ANGUS COUNCIL'S SUBMISSION RESPECT OF NON- DETERMINATION**APPLICATION NUMBER – 15/00415/FULL****APPLICANT- BOLSHAN RENEWABLES LIMITED****PROPOSAL & ADDRESS – ERECTION OF WIND TURBINE OF 55.6 TO HUB HEIGHT AND 79.6 TO
BLADE TIP AND ANCILLARY DEVELOPMENT AT FIELD 750M NORTH WEST OF BOLSHAN
FARM, BOLSHAN, ARBROATH****CONTENTS**

**15/00415/FULL Field 750M North West Of Bolshan Farm Bolshan Arbroath
Erection of Wind Turbine of 55.6 to hub height and 79.6 to blade tip and Ancillary Development
Evaluation and comments on Landscape and Visual Effects - Angus Environment & Development Plan - Planning Advice- Landscape Officer 28 May 2015**

Figure No.:	GBF/14-015/FIG C7
Version No.:	1.1
Produced by:	VS
Checked By:	JC
Date Last Amended:	25.06.2015

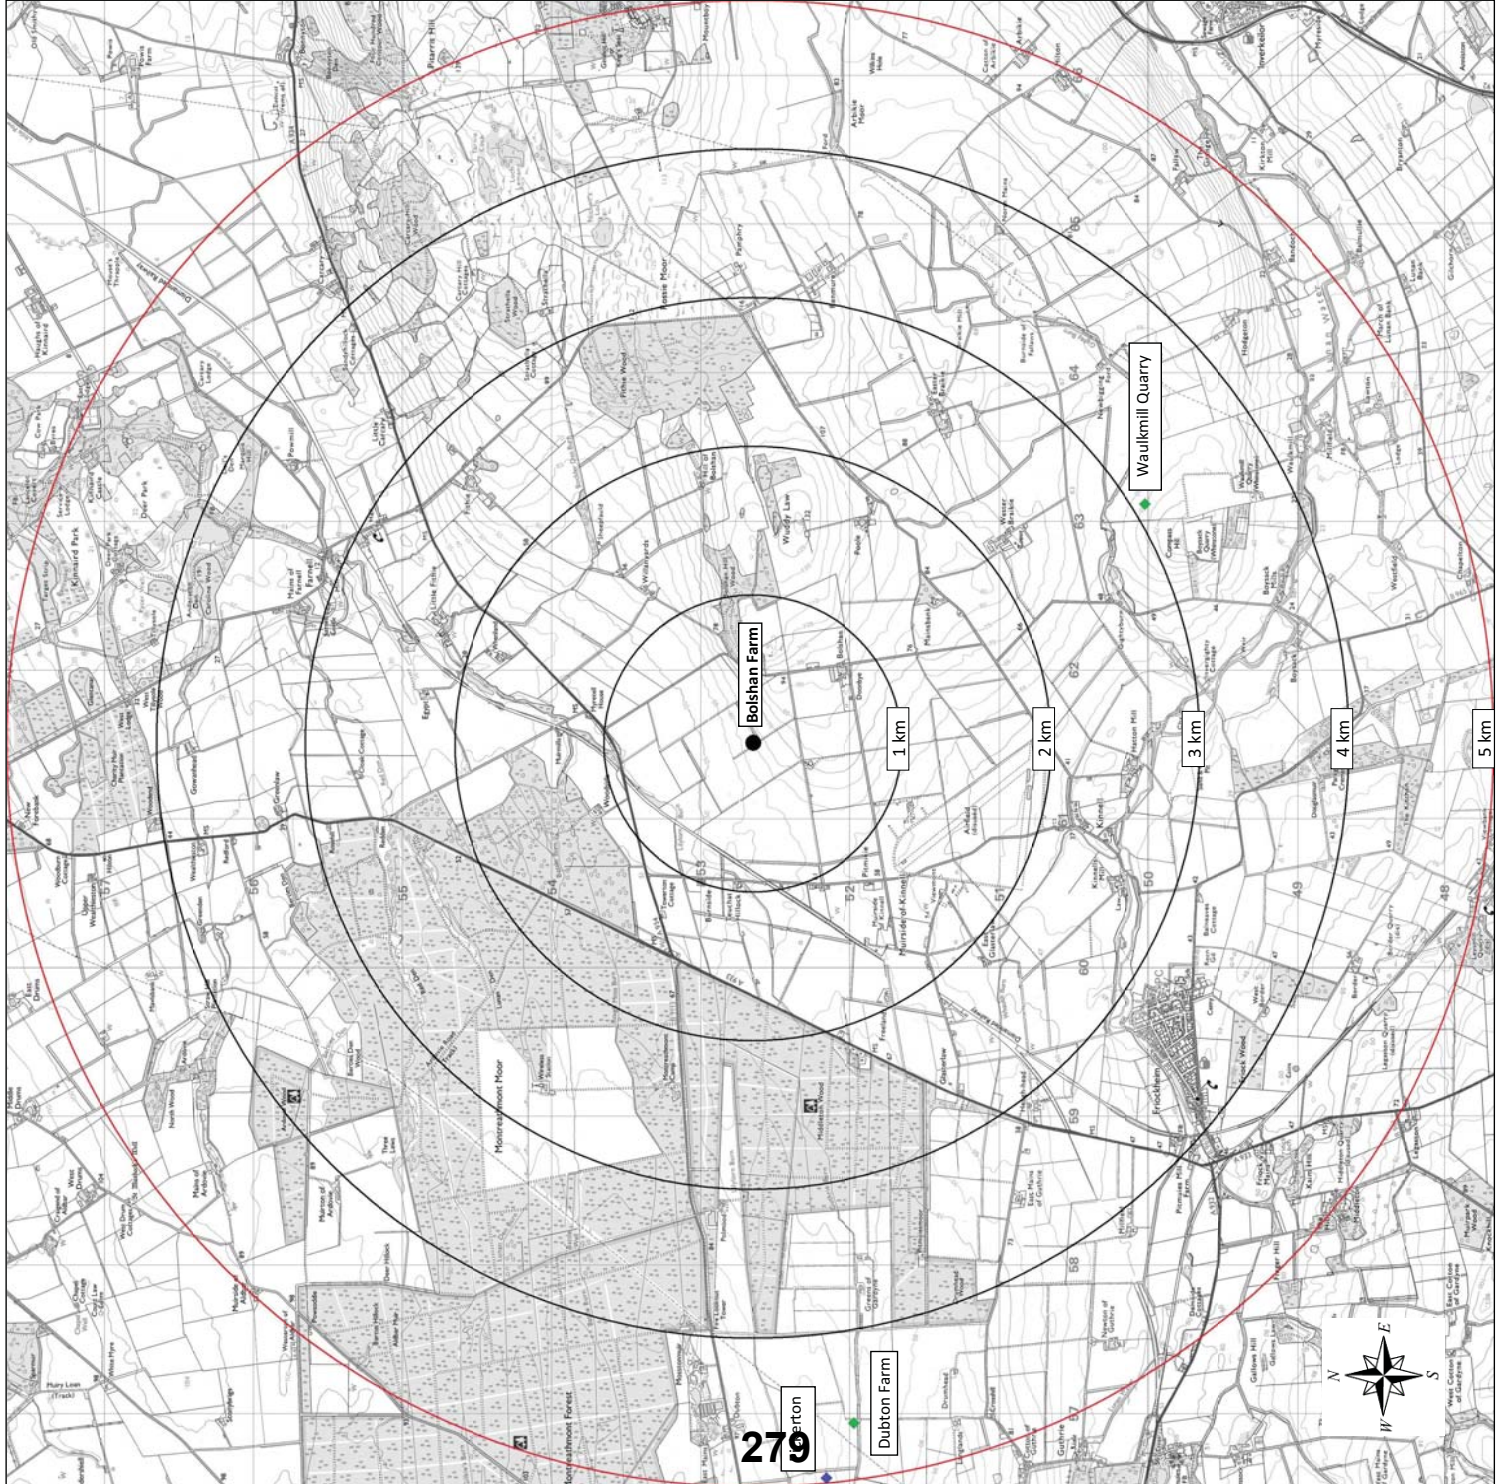
The landscape officer has listed several wind turbine projects within 5km. Due to changing circumstances some of these projects are now less relevant than before and an update of the cumulative picture is needed. With this letter I have provided an updated cumulative map to replace the information on figure C1 within the 5 km radius, this is numbered ‘Figure C7’. I have not included any project for which a planning application may have been submitted after the Bolshan application because it will be incumbent on those projects to demonstrate that their cumulative effects are acceptable given the outcome of the Bolshan turbine application. Table 1 shows the changes between figures C1 and C7:

Figure C1	Figure C7
Heughhead, 11/00143/FULL	Consented	Permission expired, no sign of initiation of development, removed from figure.
Dubton, 14/00606/FULL	Planning Application	Consented
Rossie School, 15/00013/FULL	Planning Application	Refused, no indication of appeal to LRB, removed from figure.

Figure No.:	GBF/14-015/Fig.B12
Version No.:	1.1
Produced by:	VS
Approved By:	JC
Date:	25.06.2015

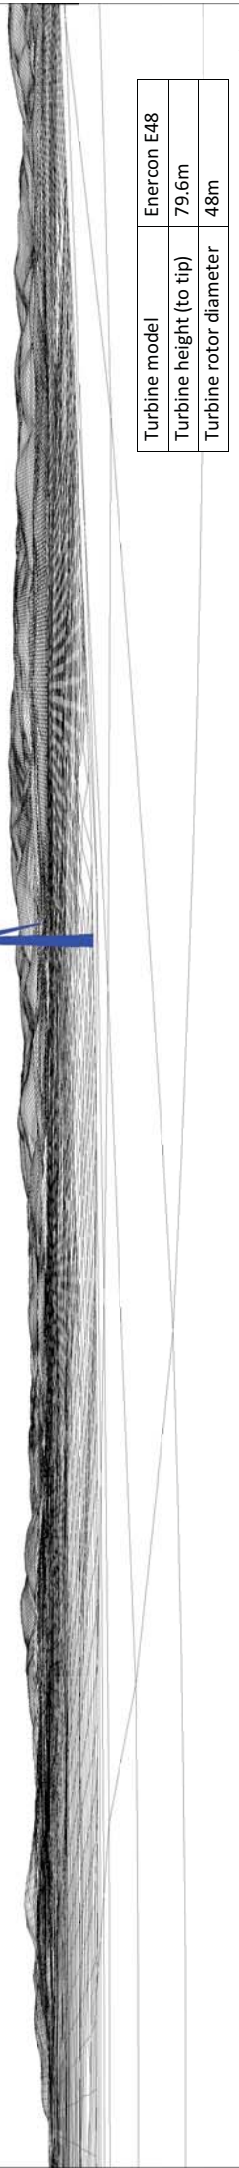
This letter is accompanied by a new photomontage (figure B12), showing a view from close to the front (western) façade of Bolshan Cottage. This is the closest dwelling to the turbine.
